LEWIS RIVER AQUATIC COORDINATION COMMITTEE

**FINAL Meeting Notes
Lewis River License Implementation
Aquatic Coordination Committee (ACC) Meeting
November 10, 2022
TEAMS Meeting Only**

Pine Creek Restoration Design Project – Cramer Fish Sciences and Columbia Land Trust

Lewis River Restoration Plan and Implementation – USFS

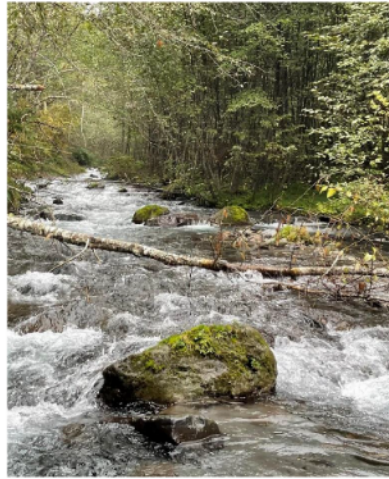
Lesko provided a few editorial comments for the final proposal. It would be helpful if Figure 1 had pattern recognition instead of colors because they are sometimes printed in grayscale. He suggested including the reaches available on Salmon Port. He noted some of the USGS gages in the area are not active anymore. He said it would be helpful to have more clarification on whether the assessment is on the whole stream or just the reaches with higher potential for restoration (1, 2, and 4). Rockhill said the assessment will include all reaches, and the design will focus on the priority reaches. Roni added they want to avoid piecemealing the assessment and design. Rockhill is aware of the USGS gages, and they use coincident records for basin extrapolation. Roni said if data are available, they will evaluate before and after eruption flow conditions.
